**OTHER CHANGE – OTH/2025/12**

776 PACIFIC PARADE, CURRUMBIN JOB – 2130201

RE: RESPONSE TO INFORMATION REQUEST 776 PACIFIC PARADE, CURRUMBIN, QLD 4223

Cozens Regan Group Pty Ltd has provided the following responses to the relevant queries raised in City of Gold Coast's Information Request (issued to John Fuglsang Developments Pty Ltd, dated 10/04/2025) related to the Material Change of Use application at 776 Pacific Parade, Currumbin.

CONCEPT ENGINEERING PLANS

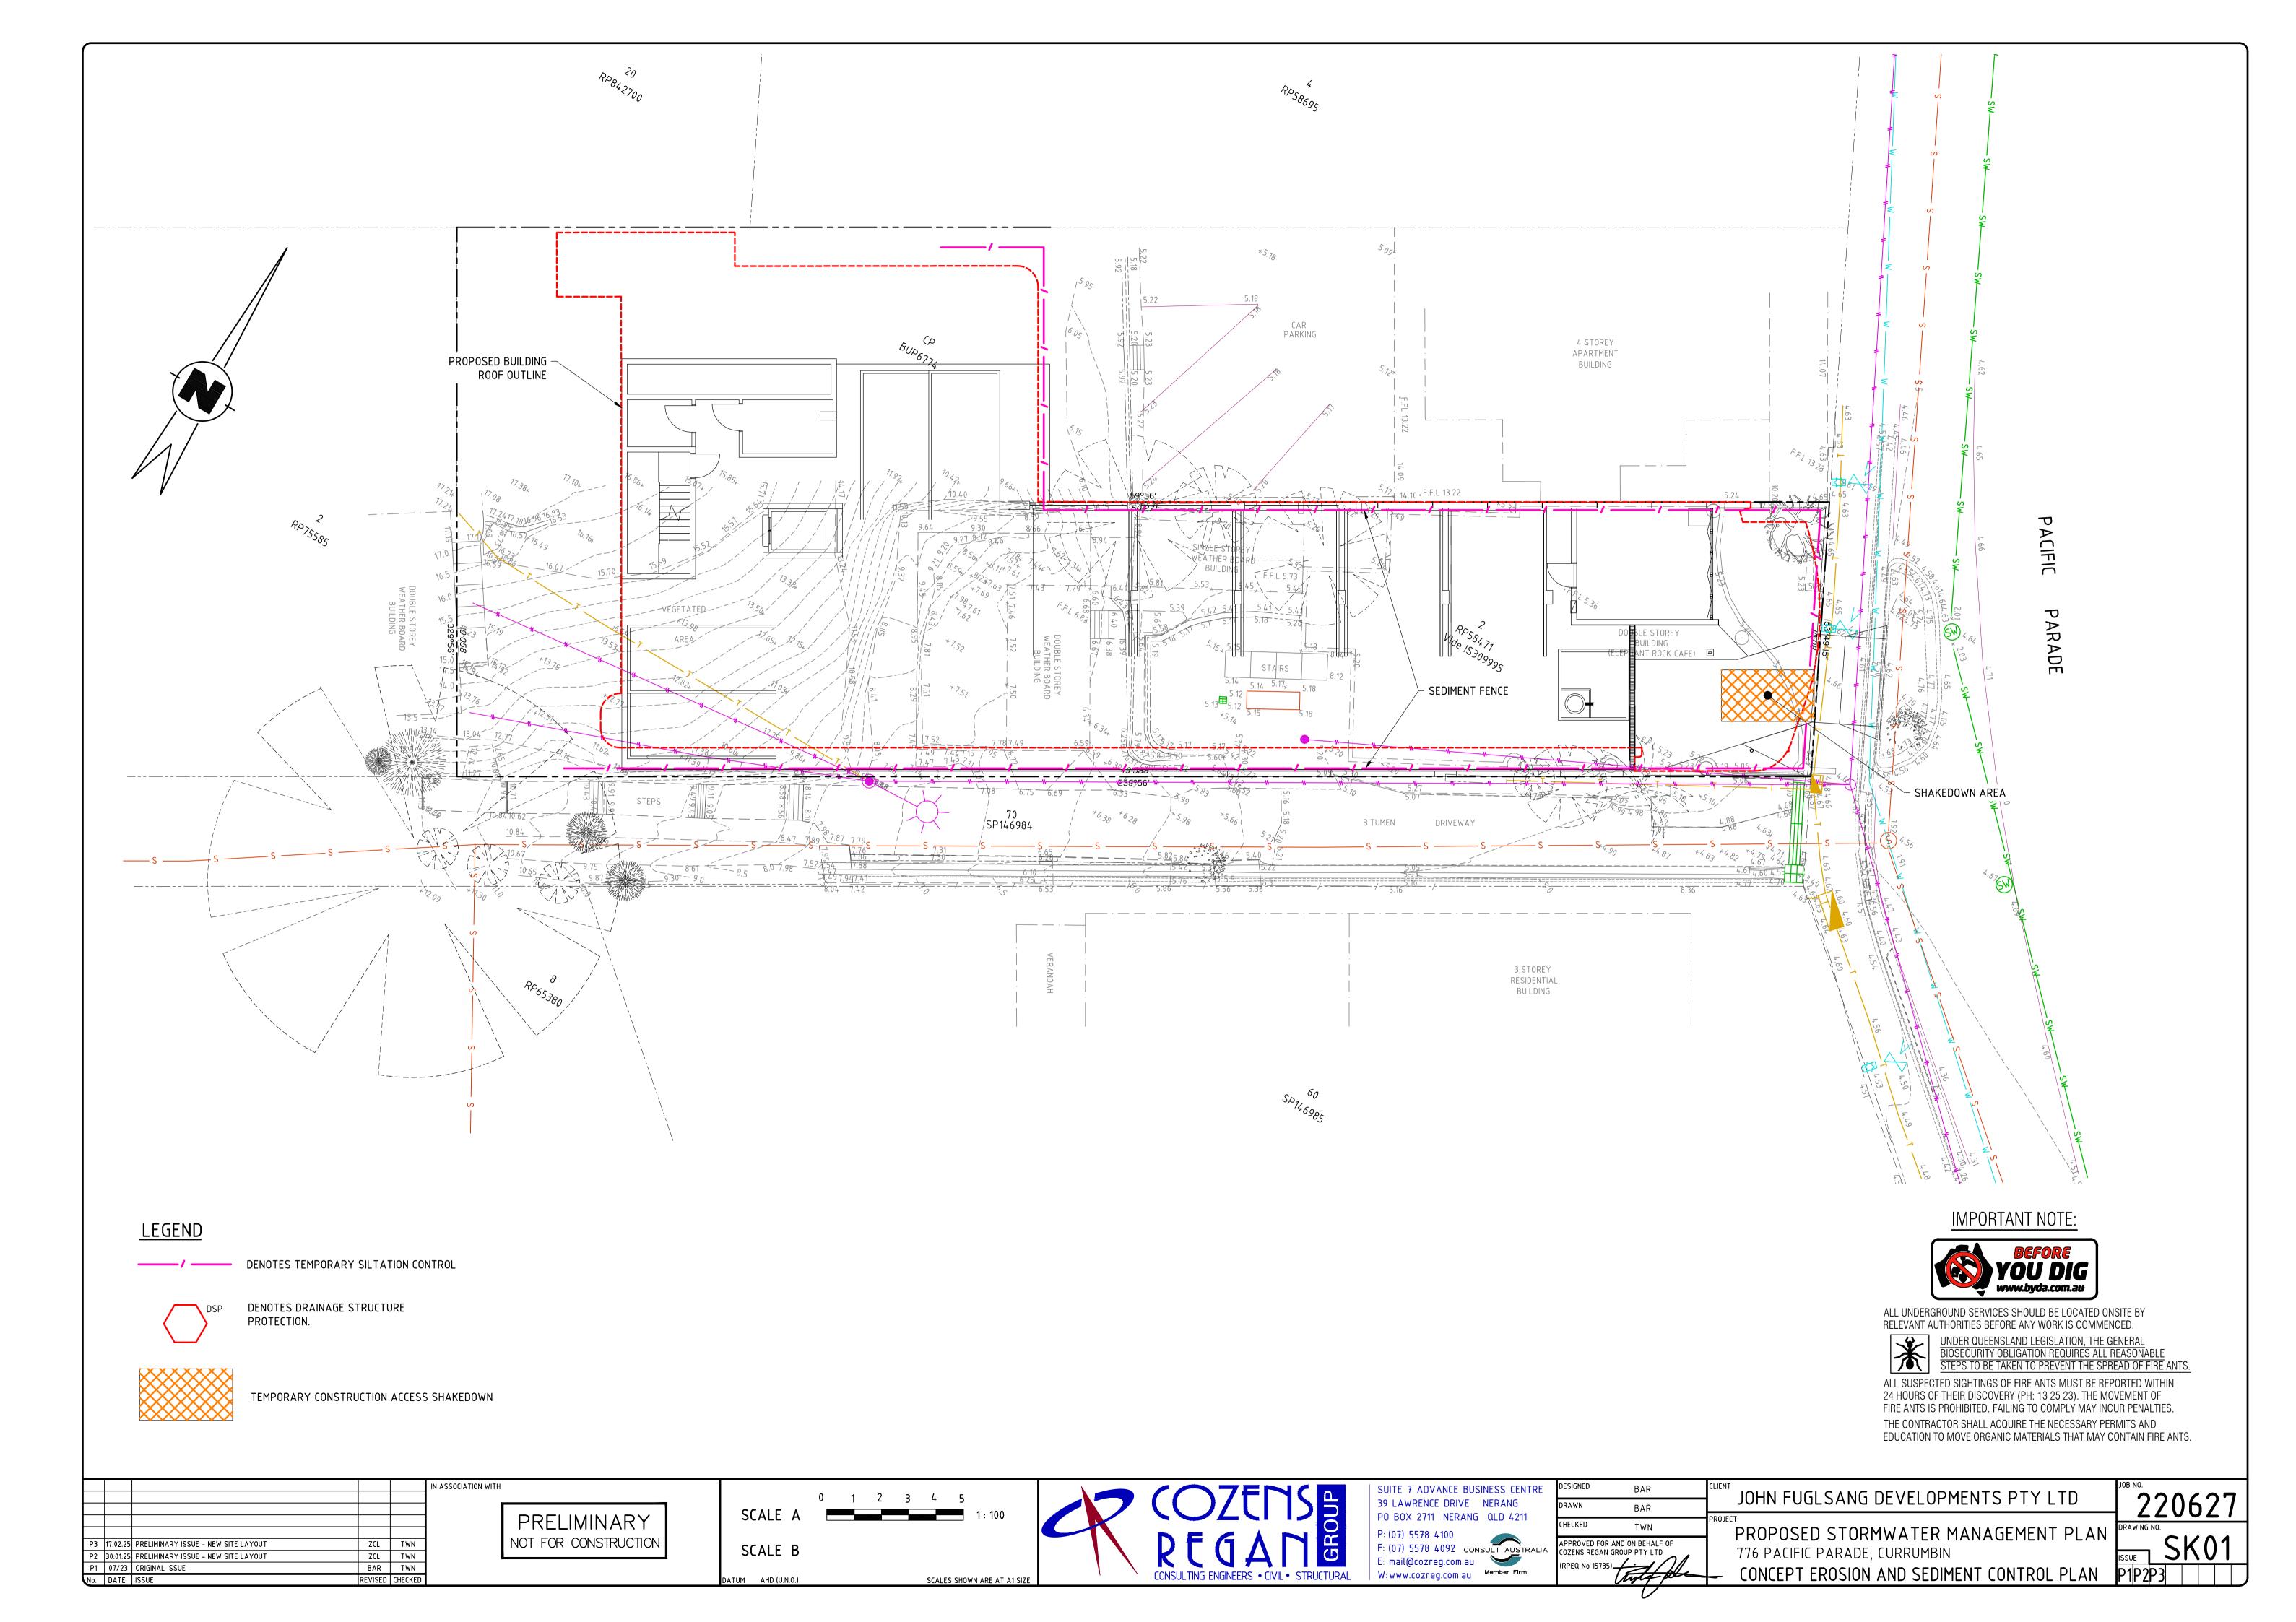
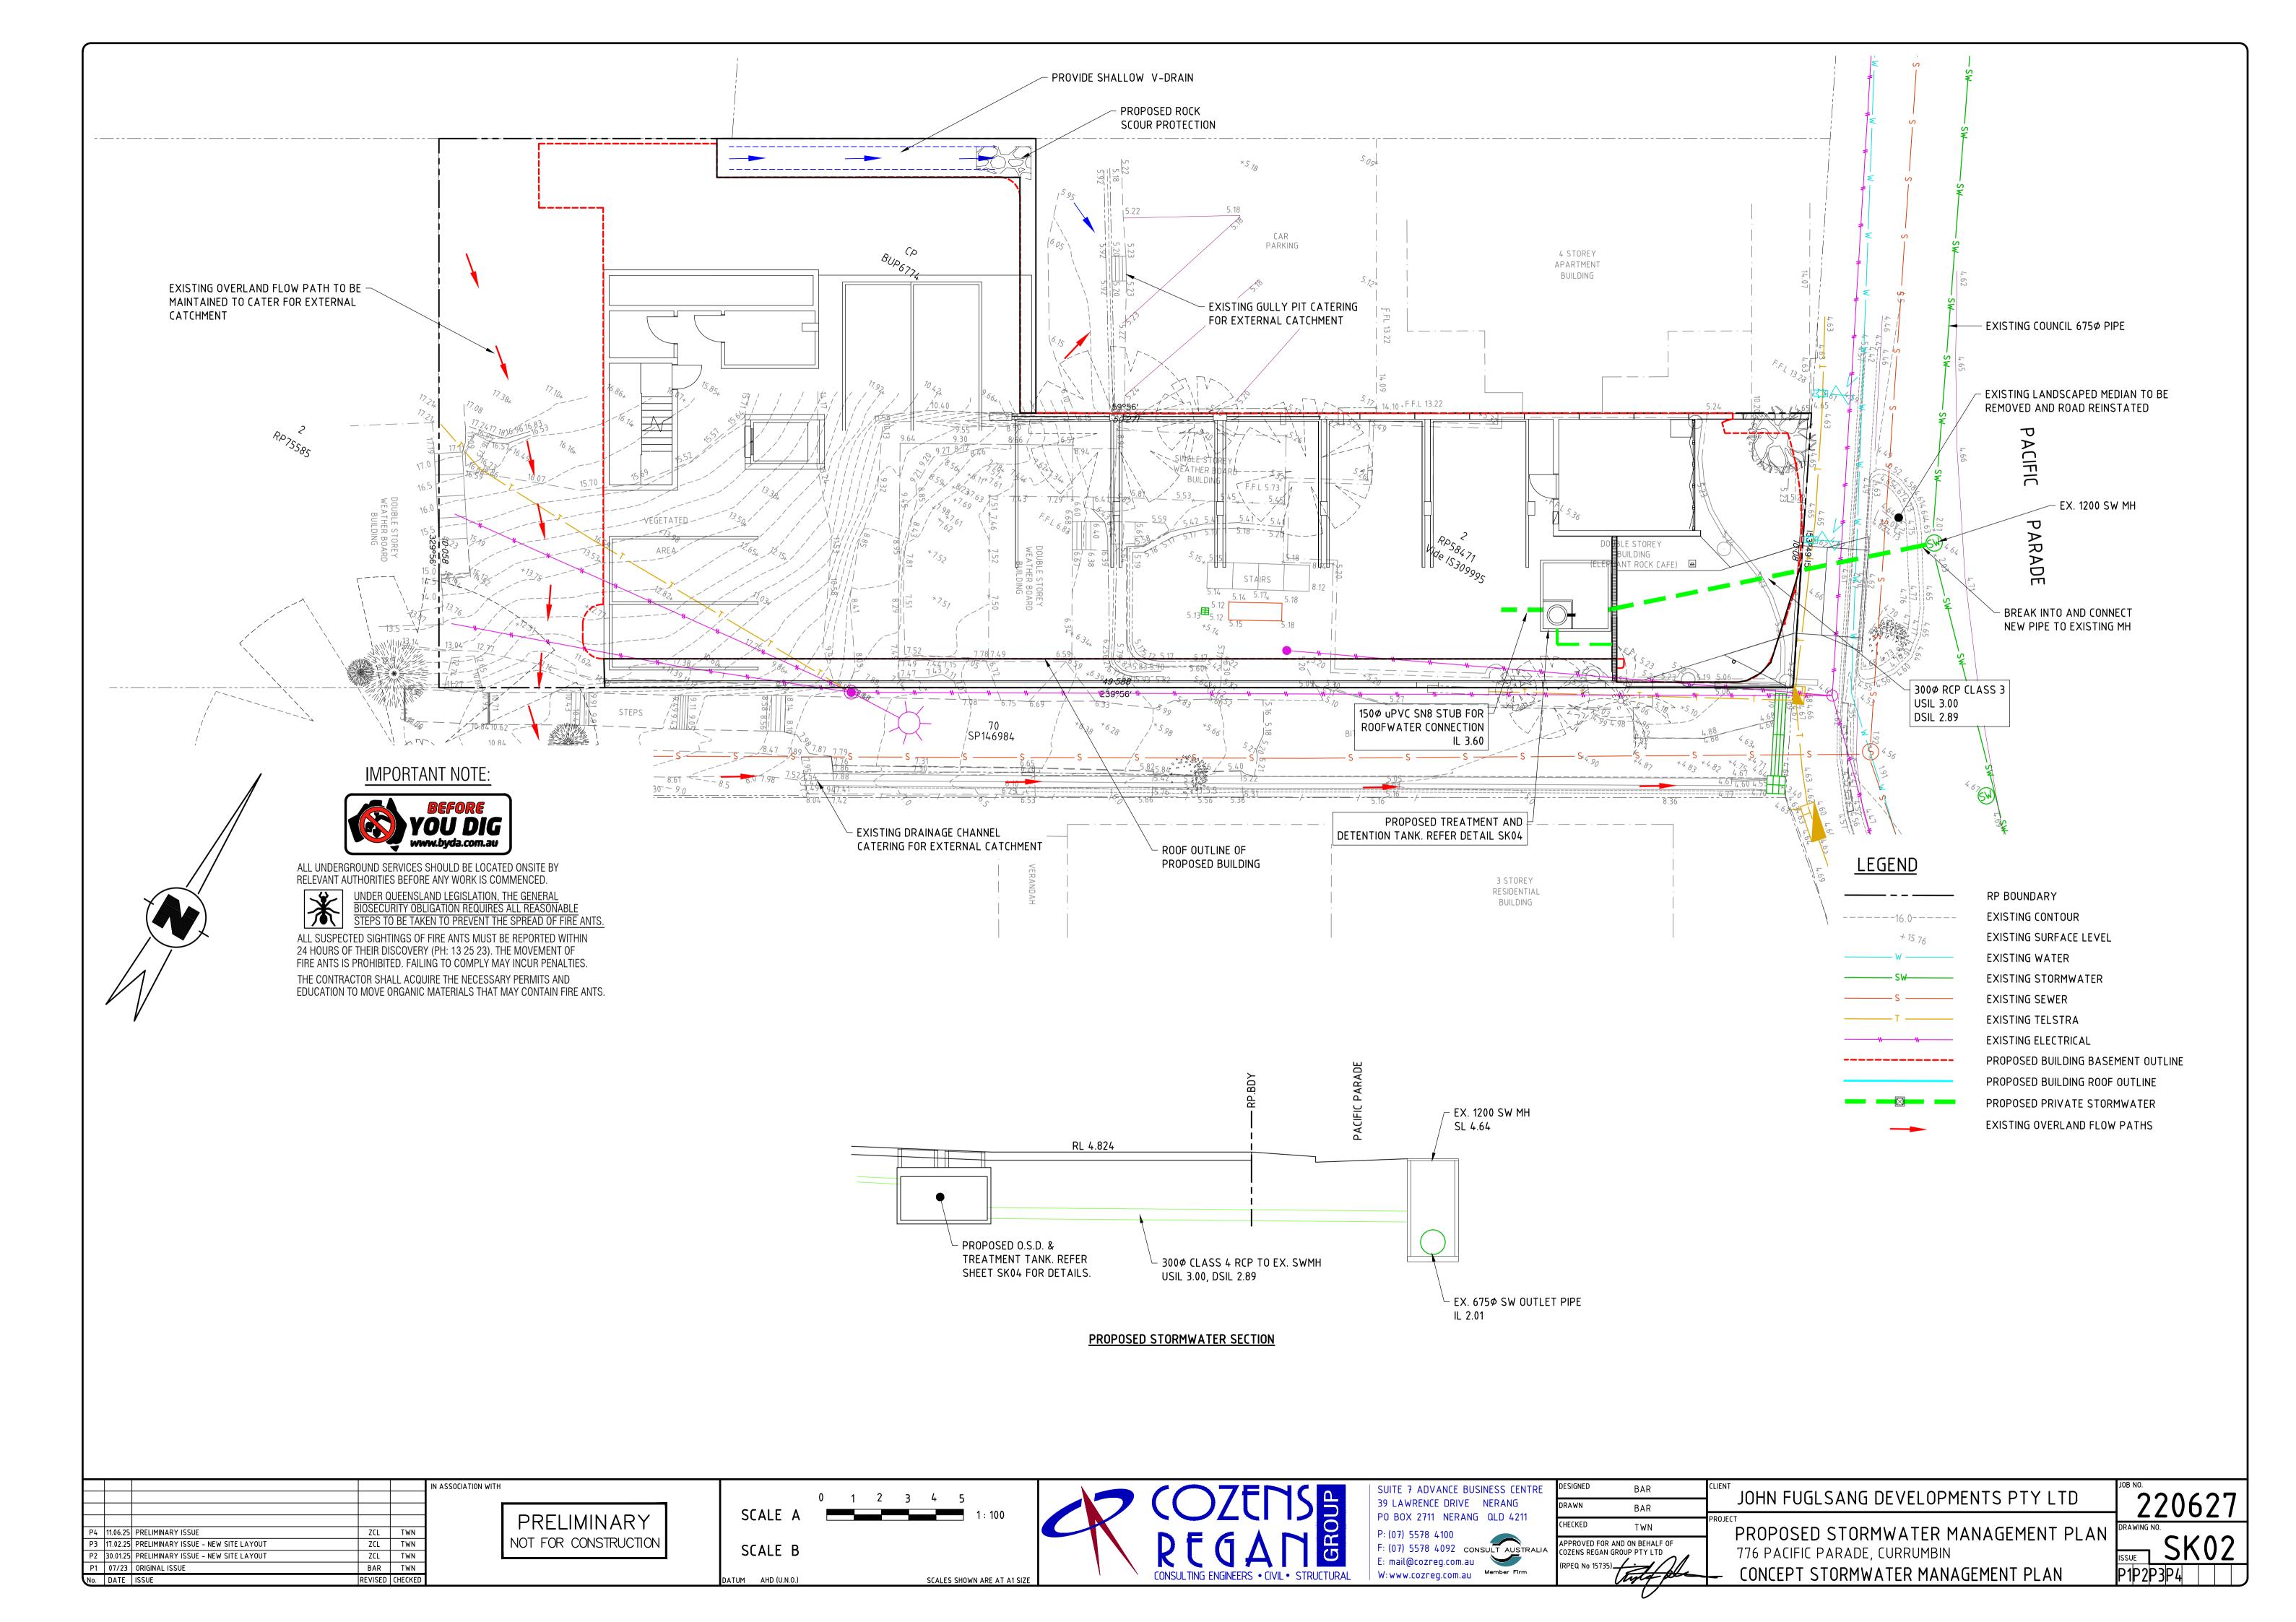
- The above-ground O.S.D. tank is no longer proposed. Please see updated drawings 220627/SK02 & SK04 which show the updated proposal for stormwater detention.
- The Stormwater Quantity Calculations show that the increase in peak runoff flow rates is very small (maximum of 4 l/s for 2% AEP event), and so a minimum detention allowance of 2m³ has been proposed and will be sufficient to cater for the negligible flow rate increase. Therefore, no modelling software has been used.
- Please refer to the updated Stormwater Management Plan Report.

- Please refer to the updated External Catchment Plan (220267/SK03).
- The overland flow path through the rear of the property is existing. In our opinion, the
  development will not increase the flow through this existing overland flow path. Therefore, it
  is considered appropriate to maintain the existing conditions to the rear of the building to
  cater for External Catchment A.
- The drainage channel to the south of the property is existing. In our opinion, the development will not increase the flow through this channel. Therefore, it is considered appropriate to maintain the existing channel to cater for External Catchment A.
- A shallow V-channel and rock scour protection has been proposed to convey the minor flow from External Catchment B. See updated drawing 220627/SK02.
